SEWAGE DISPOSAL SYSTEM
HOWARD COUNTY HEALTH DEPARTMENT
BUREAU OF ENVIRONMENTAL HEALTH
410-313-2640

P 511984-C
A REPAIR
ISSUE DATE April 2000
APPROVAL DATE 4/16/01

RE: Septic Repair Request
Woodmark Lot 42
12222 Benson Branch Road
Ellicott City, MD 21042

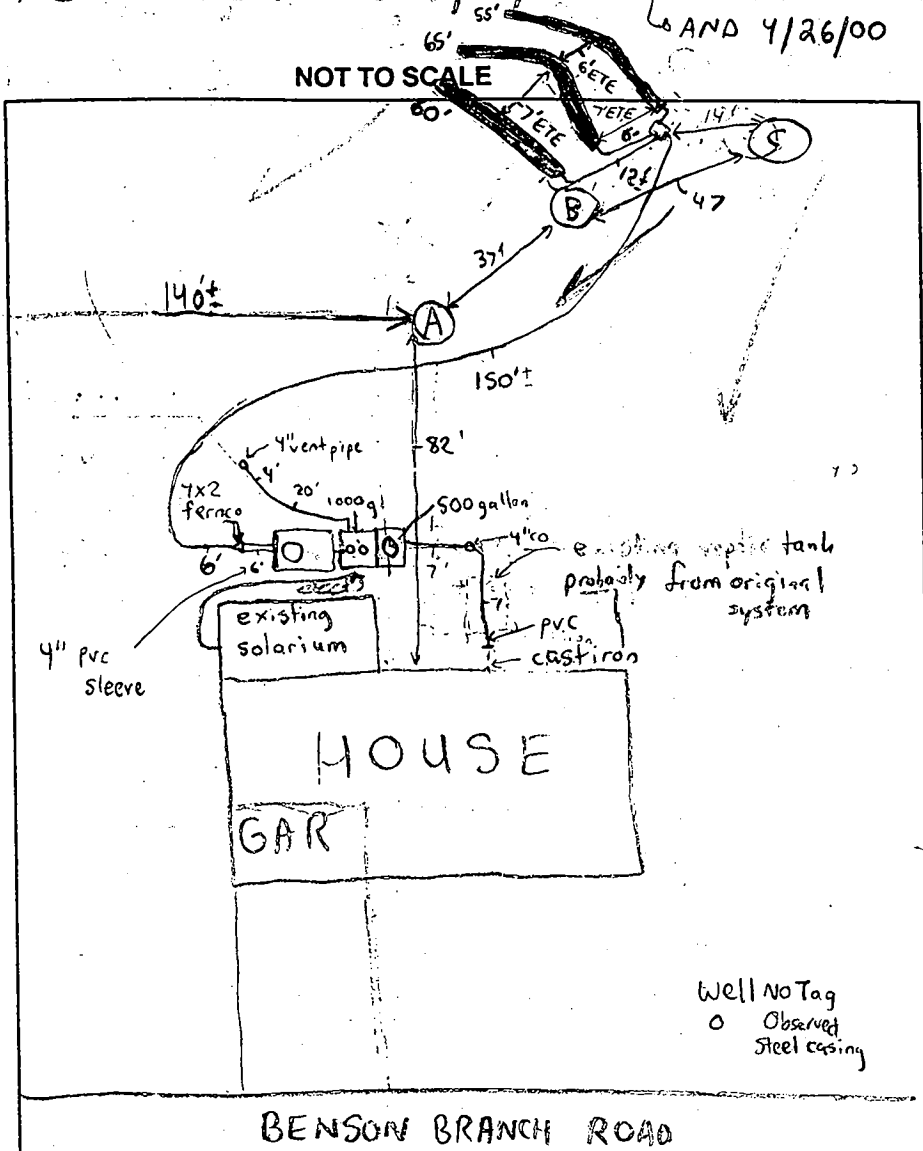
SEE SOLARIUM BP PLAN DATED 4/25/1990 FOR SOIL PROFILES DESCRIBED ON 4/5/2000. NO SPACE HERE - (SRW) AND 4/26/00

PRE-CONSTRUCTION INSPECTION: 4/5/00-MET WITH CONTRACTOR AT SITE TO DISCUSS OPTIONS FOR SEPTIC REPAIR. BECAUSE OF CONTOUR AND SOIL CONDITIONS, A CONVENTIONAL GRAVITY FLOW TRENCH SYSTEM CAN NOT BE INSTALLED (SRW). PERC HOLES ARE IN LOCATIONS (A) & (B) CONFIRM THIS. CONTRACTOR (FYAC) MENTIONED THAT THEY WILL REPLACE THE LINE FROM THE SEPTIC TANK TO THE EXISTING INSPECTION COMMENTS: TRENCHES. THIS LINE REPLACEMENT MAY HELP REMEDIATE THE CURRENT SITUATION HOWEVER IT IS A TEMPORARY SOLUTION (SRW) 4/6/00-LETTER SENT TO HOMEOWNER (MRS. MOORE) TO EXPLAIN CURRENT SITUATION AND REQUEST MEETING (SRW) 4/26/00-MET WITH MRS. MOORE AND CONTRACTOR (SOUTH CARROLL) AT SITE. DUG PERC HOLE IN LOCATION (C) SOILS SUITABLE FOR CONVENTIONAL TRENCH SYSTEM AT THIS LOCATION BUT PRESENT BOUNDARIES ARE UNCERTAIN AND AMOUNT OF AVAILABLE AREA SEEMS LIMITED. PRE-TREATMENT TO BE RECOMMENDED IF INSUFFICIENT AREA IS ESTABLISHED FOR FULL SIZED REPAIR. (SRW) 11-27-00 Per Kurt (Fooks) This repair will use all available septic area. Pre-treatment will be installed at 41501 st. treatment unit & pump chamber set on to corner.

4/10/01-EVERYTHING ON TO COVER, SYSTEM STILL NEEDS PUMP TEST FOR FINAL

APPROVAL (SRW) 4/16/01 PUMP/ALARM OK (MA)

PENCIL DETAIL TO DRAWING
 IS SEPTIC REPAIR
 EVALUATION BY SRK ON 4/5/00
 BY AND ON 4/26/00 BY SRK AND SCW

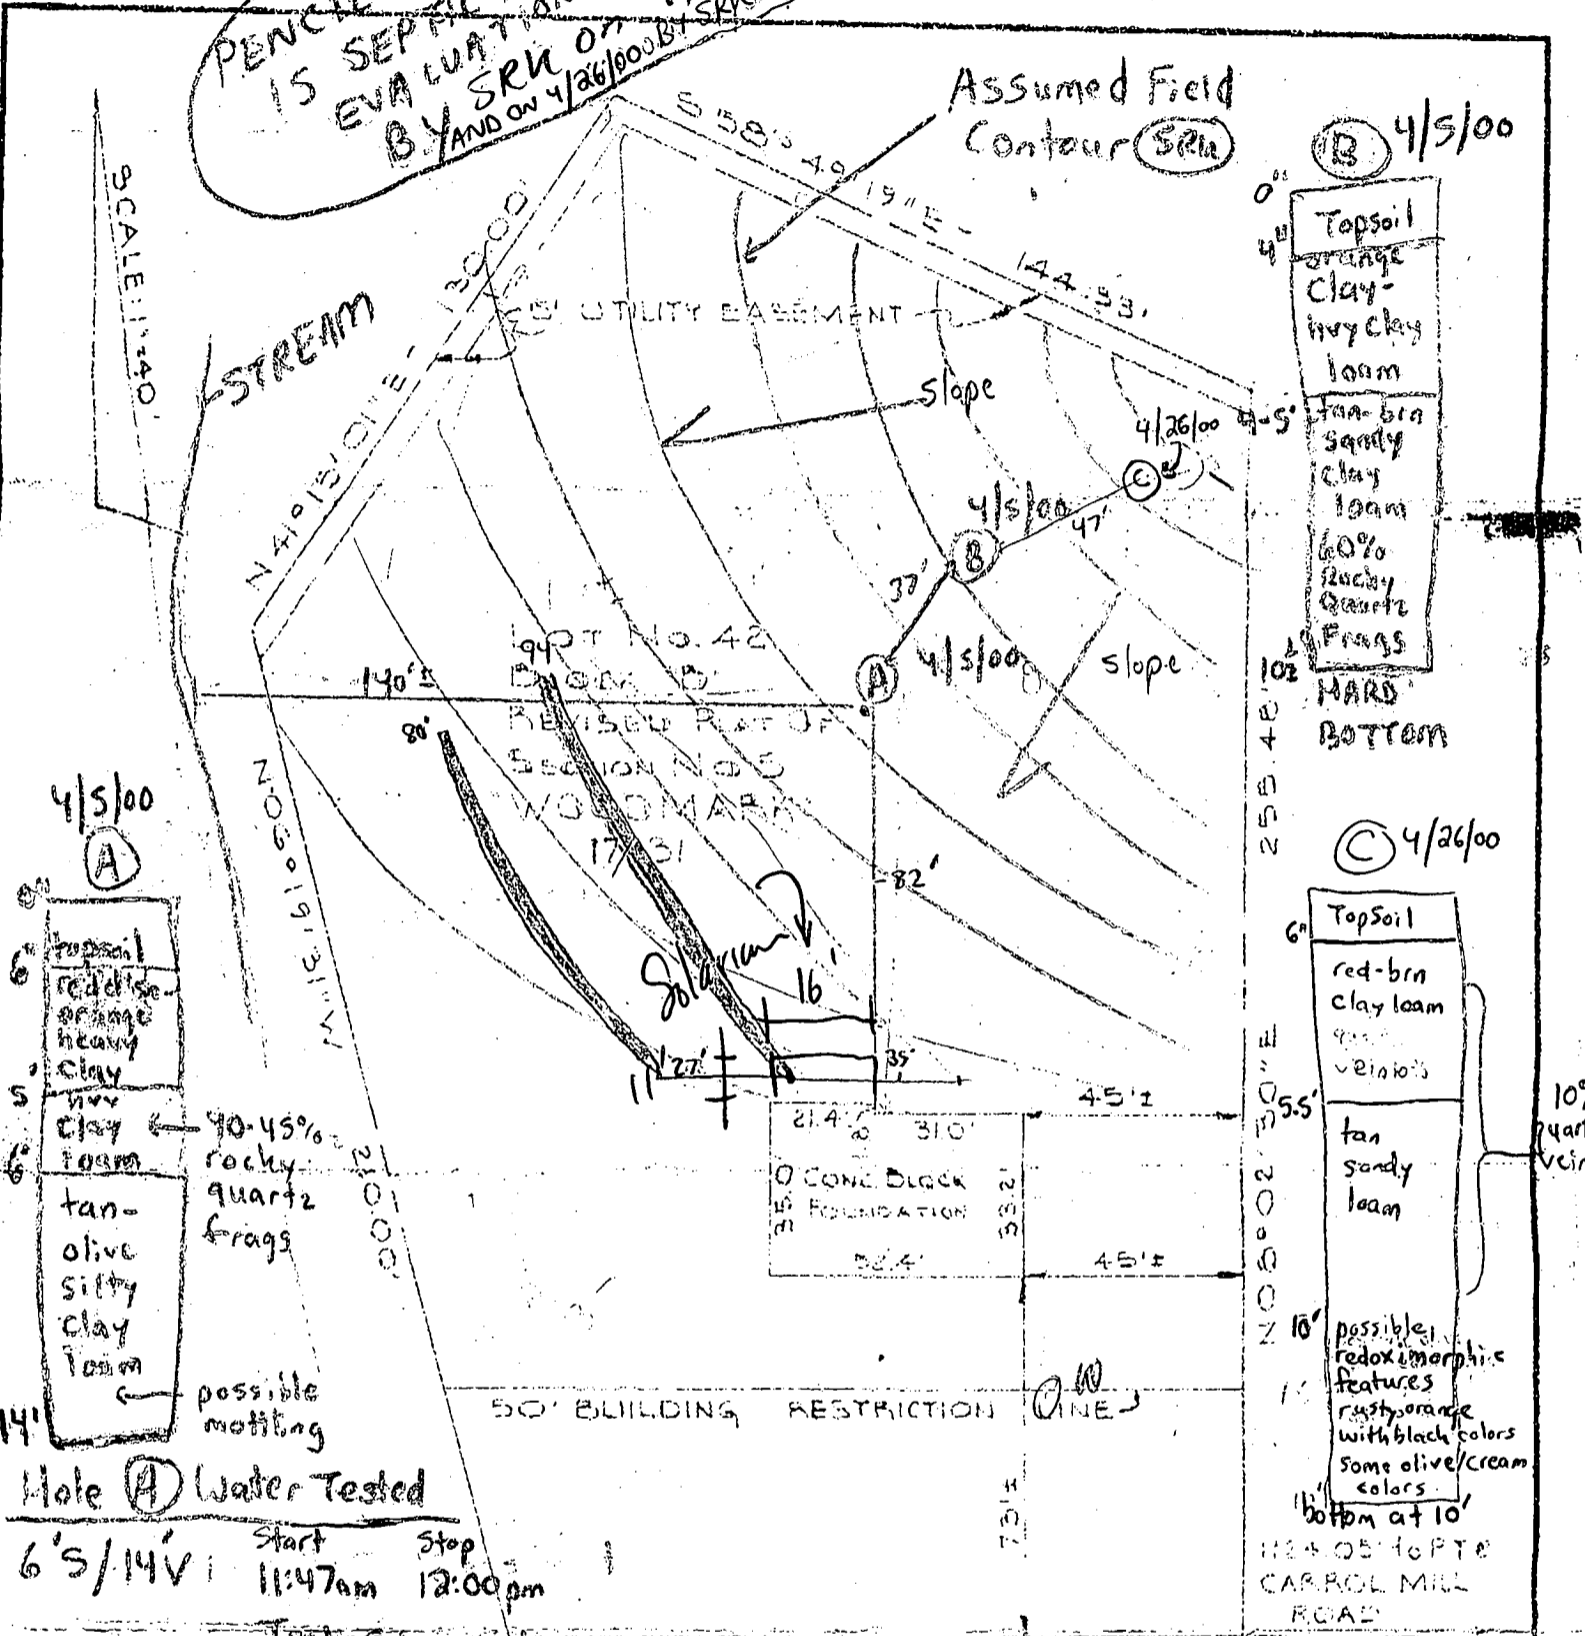
Mole C tested
 5'5/10'0 Start Stop ← No movement
 10:56am 11:30am

SOILS WILL PERC AT 5.5 to 6'

Hole A Water Tested
 6'5/14'V Start Stop
 11:47am 12:00pm

Test Stopped at 12:00pm
 13min passed no water movement to 1st peg
 Clay layer too deep here moved to hole B
